STAFF REPORT

Agenda Title: For Possible Action: Discussion and possible action regarding the adoption of Bill No. 108, on second reading, an ordinance approving the fourth addendum to a development agreement between Carson City and Silver Oak Development Company Limited Partnership to modify Article 2.2 Cluster Housing of the Silver Oak Development Agreement, and providing other matters properly related thereto on properties zoned Single Family 12,000 Planned Unit Development (SF-12 P), located on the south side of Silver Oak Drive, east of Siena Drive and Red Leaf Drive, and a parcel located southwest of Eagle Valley Ranch Road, and further identified as APNs 007-552-44, 007-552-38, 007-552-19 and 007-552-41. (Hope Sullivan, hsullivan@carson.org)

Exhibit "A"
FOURTH ADDENDUM TO DEVELOPMENT AGREEMENT

FILE NO: PUD-2020-0002

VICINITY MAP:

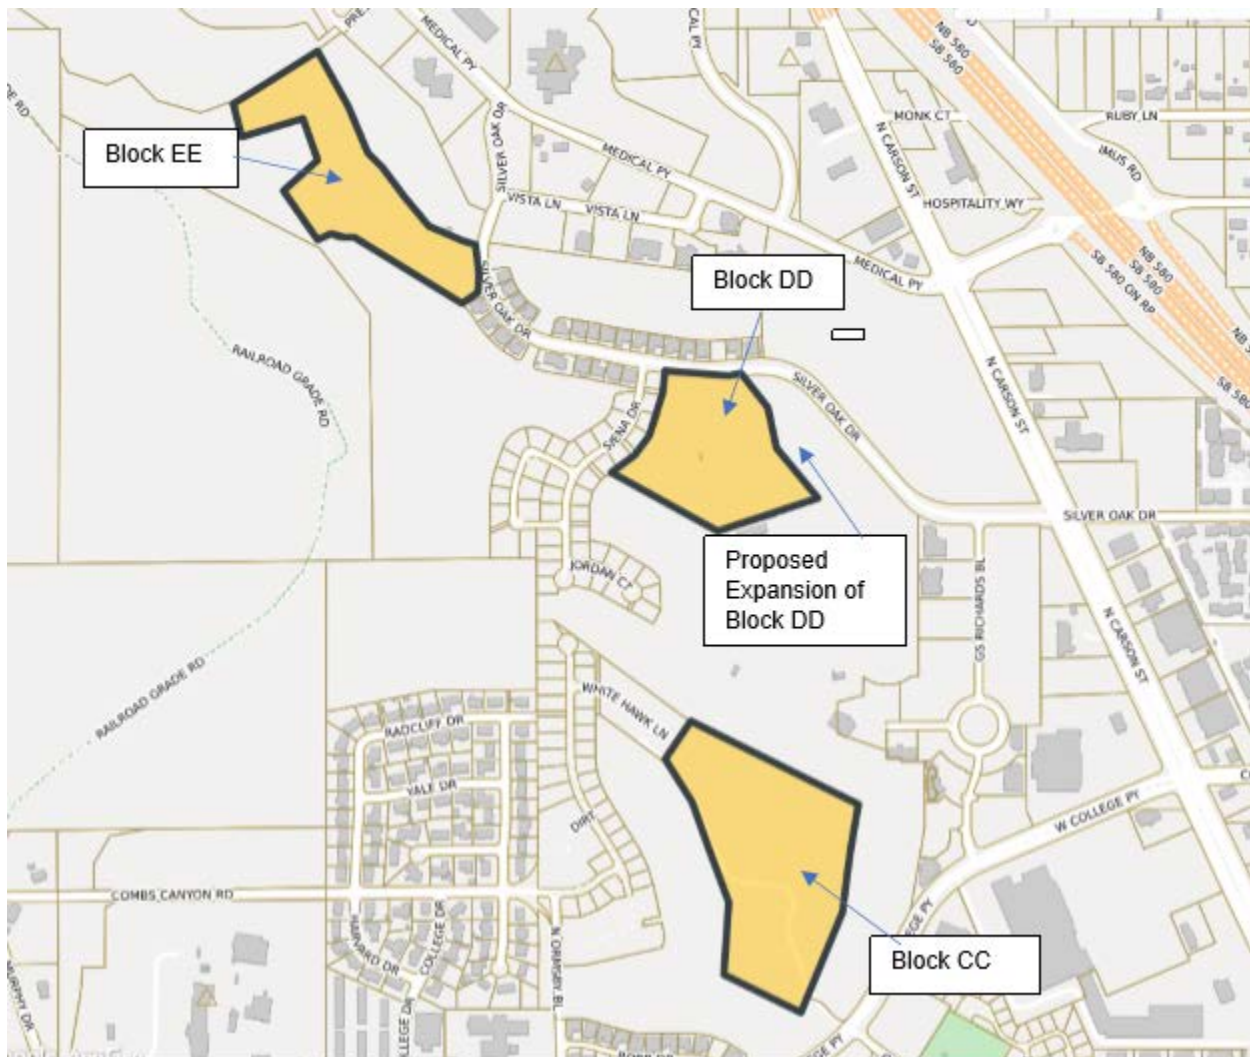
1. The allowable density in Block “DD” is changed from 92 units to 64 units.
2. The following wording is to be removed “with building types of zero lot line townhome, common wall or similar units referenced in the project approval.”

3. The following wording is to be removed “Lot coverage cannot exceed thirty five (35%) percent of the lot areas, including covered parking and ...”
4. Modify the reference to building height to state “The building height may not exceed 28 feet. This limitation supersedes the condition of approval that allows for a building height of 35 feet.”

5. Modify the front setback requirements to state the requirement is ten feet to the house, 18 feet to the garage, measured from the back of sidewalk if there is a sidewalk on the property.

6. Modify the rear setback requirements to state the requirement is ten feet for front access units, and five feet to garage doors from alleys or rear property lines if a rear access.

7. Modify the side setback requirements to state the requirement is five feet, or zero on one

- side and ten feet on the other.
8. Wording that the two story elements shall not exceed 50 percent of the structure's frontage shall be removed.
 9. Wording that a maximum of two units in a row with the same setback shall be removed.
 10. Wording will be added that at the time of application for a site improvement permit for block "CC," "DD," or "EE," the applicant shall submit a signal warrant analysis for the intersection of Silver Oak Drive and North Carson Street reflecting build out of all three blocks.
 11. The boundary of Block DD may be expanded as proposed.
